HISTORIC AND DESIGN REVIEW COMMISSION

HDRC CASE NO: 2015-023
ADDRESS: 415 E PARK AVE
LEGAL DESCRIPTION: NCB 1752 BLK 5 LOT E 25 FT OF 6 & W 13.29 FT OF 7
ZONING: R4 H
CITY COUNCIL DIST.: 1
DISTRICT: Tobin Hill Historic District
APPLICANT: Jennifer Boone
OWNER: Manuel Mendoza, Yolanda Mendoza
TYPE OF WORK: New construction of 2-1/2 story residence
REQUEST:

The applicant is requesting a Certificate of Appropriateness for approval to construct a 2-1/2 story single family house. The proposed design will have a metal roof, vinyl windows, cement board plank and shingle siding and a rooftop balcony.

SOUTH ELEVATION (Front)

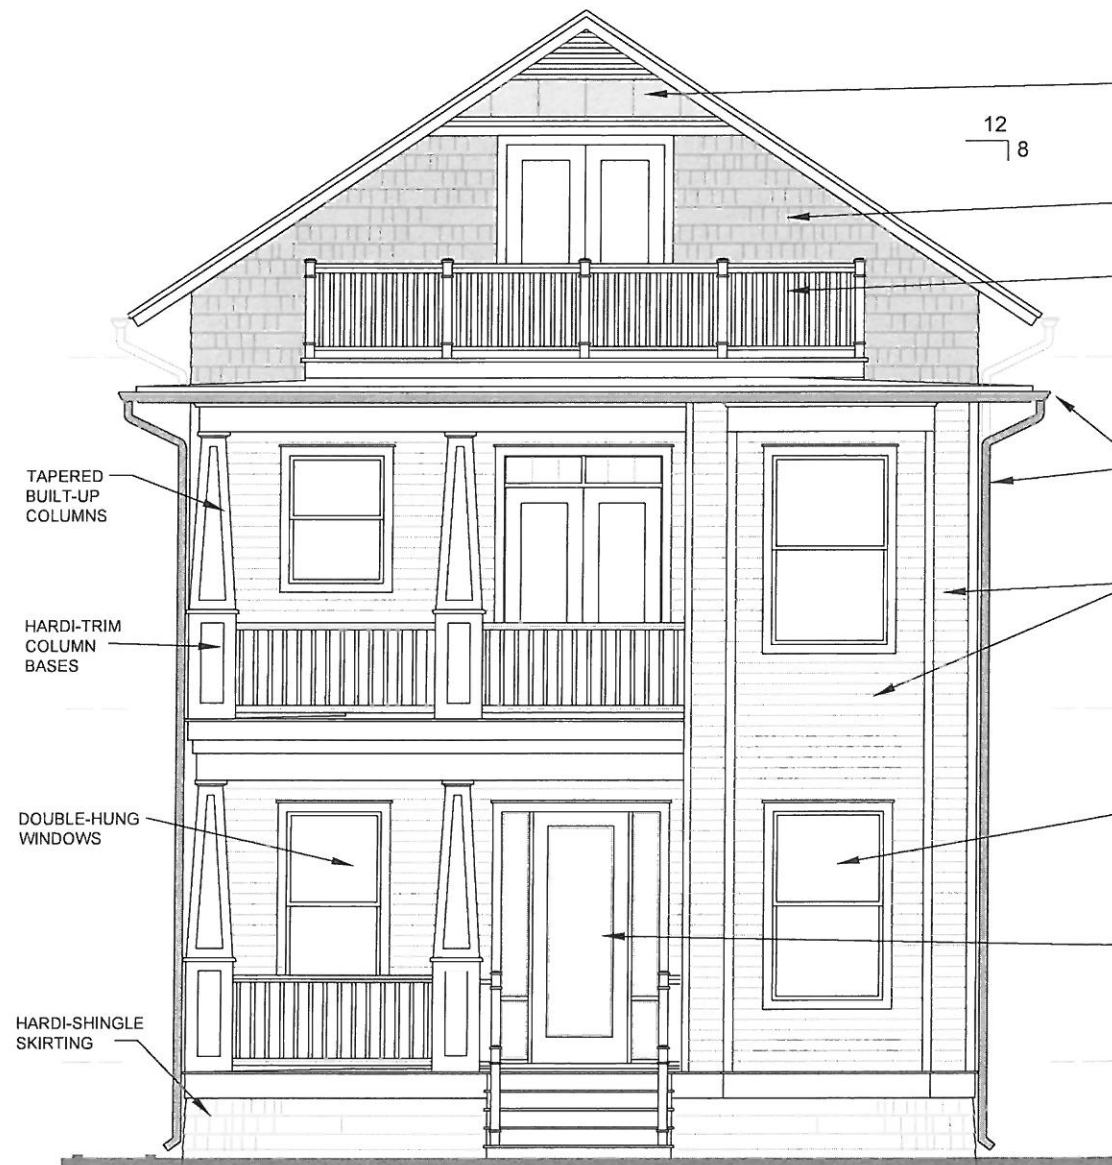
- e. According to the Guidelines for New Construction, front facades of new buildings should align with existing buildings when there is a consistent setback along the street. Houses on this block of East Park have an overall consistent setback that should be preserved. Although the front wall behind the porch on the main house aligns with front walls of adjacent houses, the solid two story portion of the house extends past the front wall of the adjacent houses which is not consistent with the guidelines.

- i. According to the Guidelines for New Construction, new buildings should be of their time while respecting the historic context. Architectural details that are in keeping with the predominant architectural style along the block face are recommended when they are simple in design and complement, but not visually compete with the character of the adjacent historic structures. The proposed Craftsman style columns visually compete with the surrounding historic structures and are not consistent with the guidelines. Simplified square or round columns would complement the adjacent houses and be more appropriate for their setting consistent with the Guidelines for New Construction.

BF-CEASEMENT PROBABLY NOT AN ISSUE IN THE BACK. FEELS LIKE
MANY OF THE PREVIOUSLY ADDRESSED ISSUES HAVE BEEN ADDRESSED/
RESOLVED. BRINGING ROOF FORWARD + WINDOW, SKIRT, FENCE
CHANGES HAVE DONE A LOT FOR THIS PROJECT. CONCERNED ABOUT
COLUMNS. *APPLICANT HAS STATED THAT COLUMN DESIGN IS TO REMAIN
AS IS. * APPLICANT HAS AGREED TO WORK WITH
STAFF ON THE COLUMNS

- a. The front setback matches adjacent houses.
- b. The front porch columns are simplified.
- c. The roof incorporates panels that are 18-21" wide, ridges less than 2" high, and a double muntz seam or low profile cap with no ridge vent.
- d. The drawings are further developed to reach at least 80% completion.
